RE: **12-DR-2024**
The Bishop
918N8 (Key Code)

Planning & Development Services has completed review of the above referenced development application submitted (payment accepted) on 6/03/2024. The following comments represent issues or deficiencies identified by the review team and are intended to provide you with guidance for compliance with city codes, policies, and guidelines.

LOCATION 2

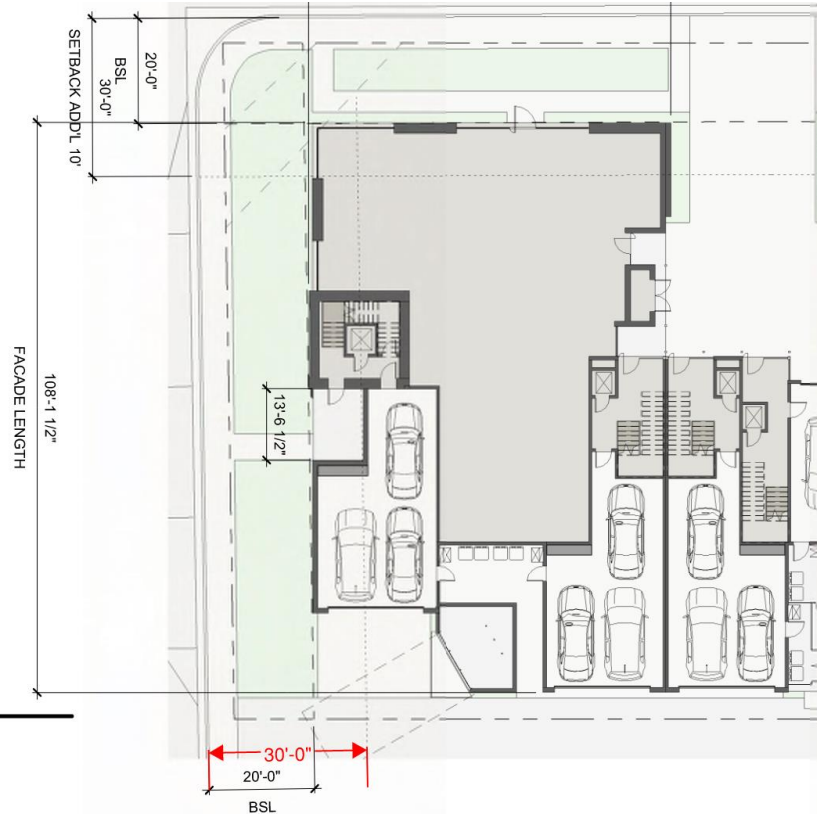
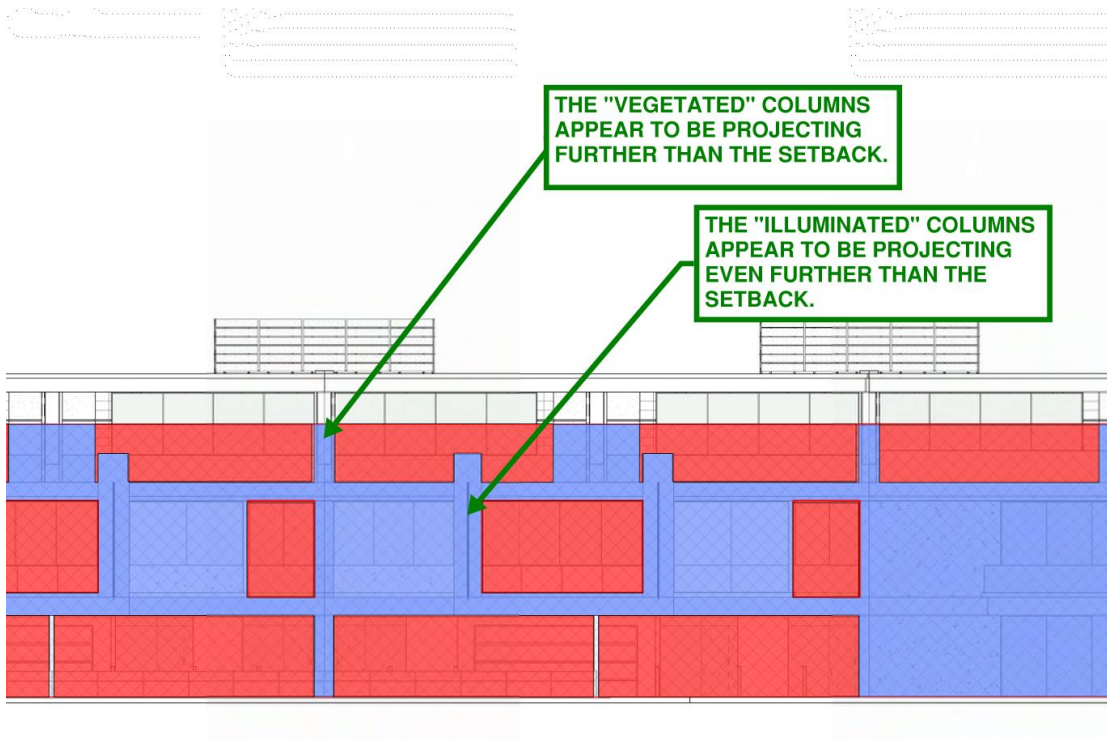
16. Building Location: ii. Length of building façade @ grade and up to a height of 45' shall be setback at least 10 additional feet (north façade) – Level 1 Façade 2 is only showing 13'-6 1/2" at the 30-ft setback line, but the summary table indicates that 29'-5" is setback at the 30-foot setback line. Please clarify and update plans accordingly:

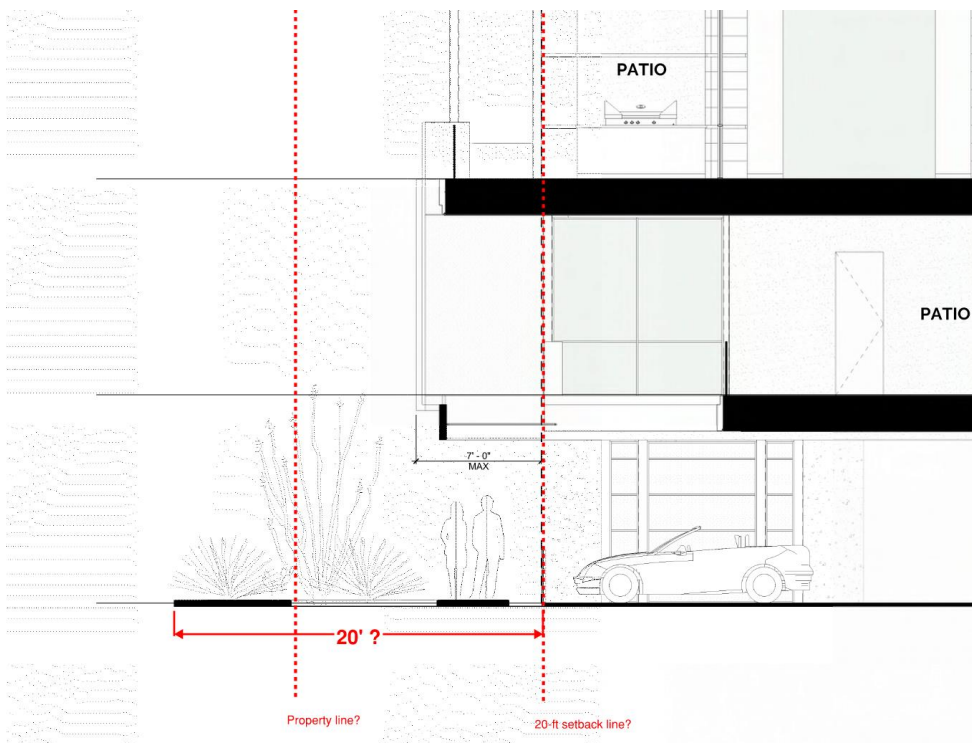
17. Building Location: iii. Area of the building façade at grade and up to a height of **45'** shall be located at the min. setback line (east façade) – East Elevation Façade Location 3 is including parts of the façade that are not located at the building setback line including the “vegetated” columns and the larger “illuminated” columns. Please remove any part of the façade from this calculation that is not located at the min. setback line:

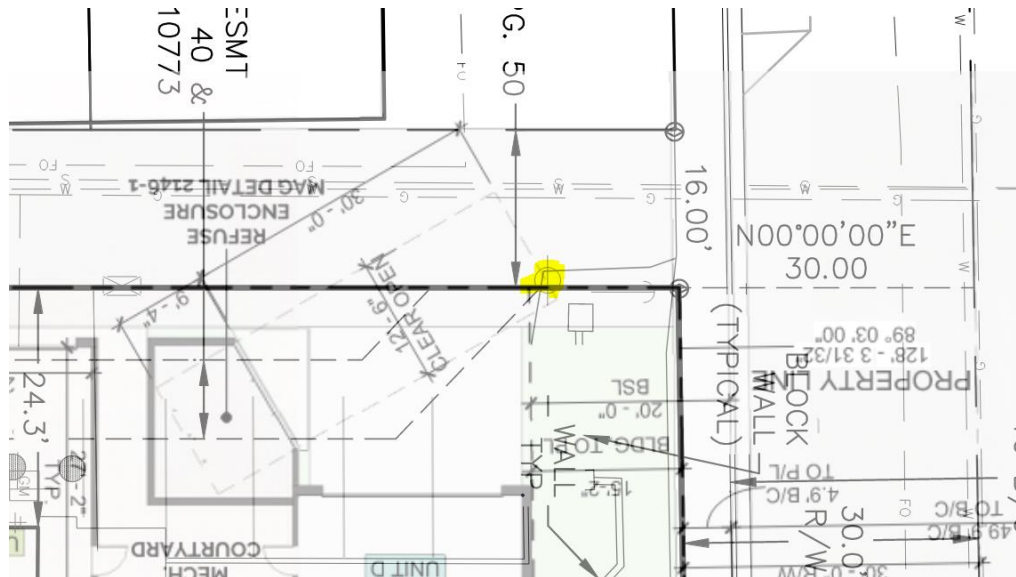
39. Please increase the height of the screen wall along the podium parking to a maximum height of six (6) feet and replace the mesh material with perforated metal paneling (or similar) to help add visual interest to the pedestrian level (DRB Criterion 1.904.A.2.b). Furthermore, ground floor areas of a development project shall activate the street by promoting an enhanced level of design to help strengthen the overall pedestrian environment (OTSUDAG). The proposed screen wall shall be designed to break up any monotonous or repetitive aspects of a lengthy wall by incorporating adequate articulation and planar shifts in the wall. Be advised, the Development Review Board and

City Council will anticipate an enhanced level of design for the proposed podium parking as all recent developments in Old Town have incorporated underground parking with their new development proposals.
